Re: Recommendations re: Sandia National Laboratories' Mixed Waste Landfill Permit Modification - Corrective Measure Implementation Plan (CMIP) and Fate and Transport model (FTM) for the Mixed Waste Landfill.

Sandia National Laboratories'
Corrective Measure Implementation Plan (CMIP)
Fate and Transport model (FTM) for the Mixed Waste Landfill (MWL)

Assessment That the Monitoring Wells Installed at the Sandia Mixed Waste Landfill do not Meet the Requirements of the RCRA Statute Subpart F, the NMED Consent Order, or DOE Orders for Selection of Remedy or for Long-Term Compliance Monitoring, Final Version. 06-05-06 by

Figure 1. Map of the 2.6 Acre Sandia Mixed Waste Landfill
The 6 Monitoring Wells are MWL-MW1 to -MW6
The 1 Background Well is MWL-BW1

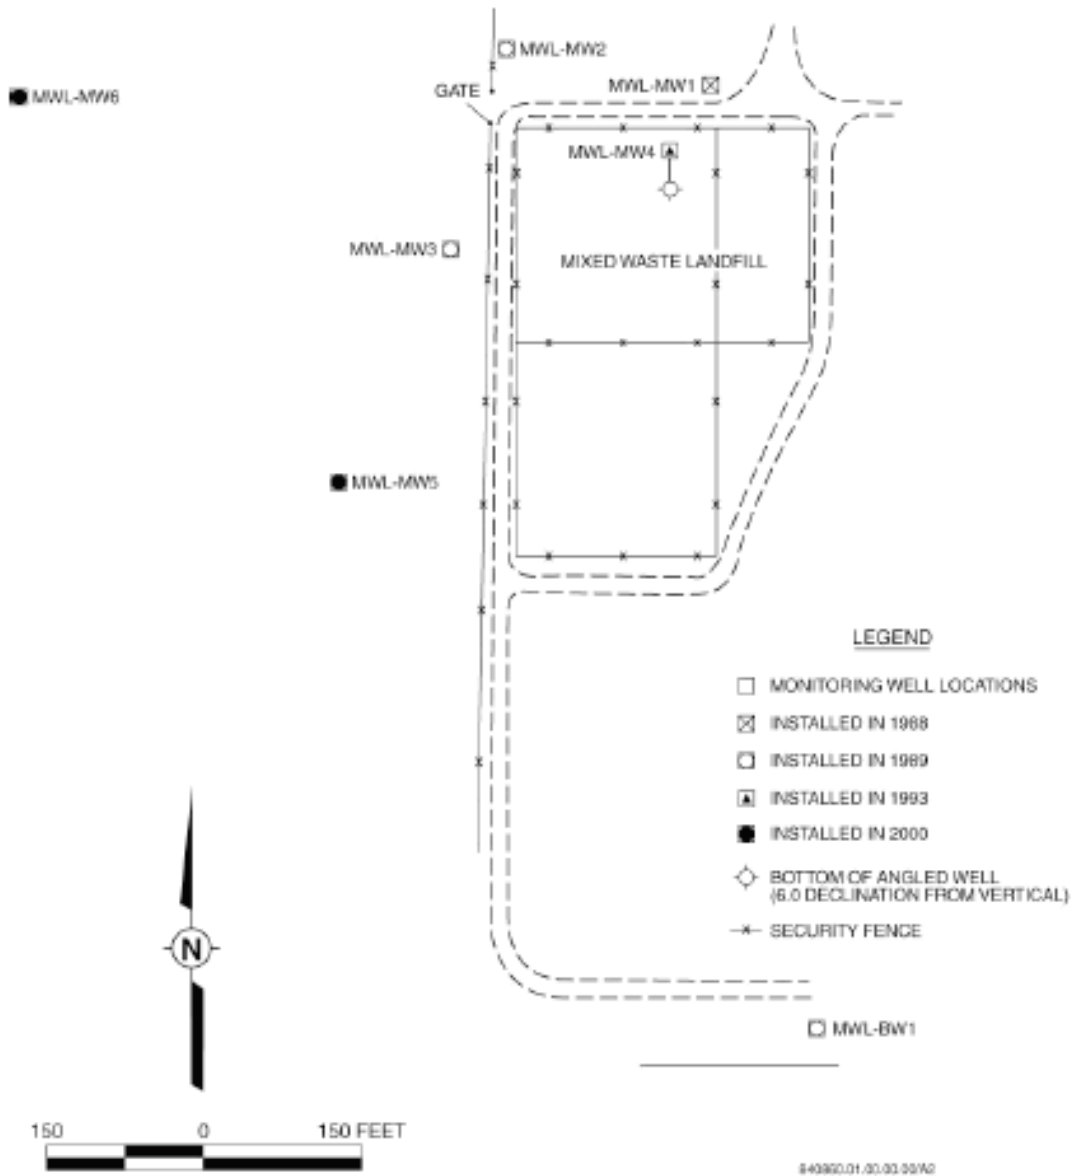
The locations of the monitoring wells at the mixed waste landfill are shown on Figure 1. The mud rotary drilling method was used for the boreholes of monitoring wells MWL-MW2, MWL-MW3, and MWL-BW1. This drilling method invaded the aquifer strata that surround the screened intervals of the three wells with large quantities of bentonite clay drilling mud, and perhaps also with organic drilling additives. The effects of bentonite clay and organic drilling additives to plug the permeability of aquifer strata and to prevent monitoring wells from providing representative water samples are well known in the technical literature and are summarized in Appendixes A and B.

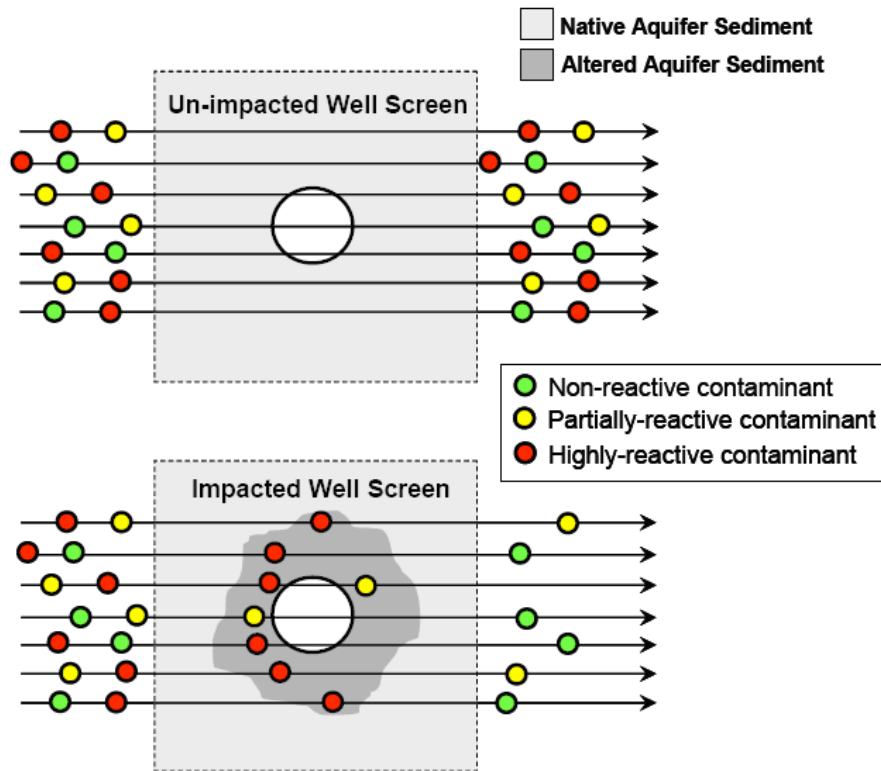
The figure only addresses the chemical properties of the barrier and not the properties of the barrier to lower the permeability of the aquifer strata and therefore, create a zone of stagnant groundwater. Because of the stagnant zone, the water produced from the impacted well screens is non-representative for all contaminants.

- Examples on non-reactive chemical contaminants are chloride and tritium.
- Examples of partially-reactive chemical contaminants are nitrate and perchlorate.
- Examples of highly-reactive chemical contaminants are volatile solvents, trace metals, and most radionuclide contaminants.
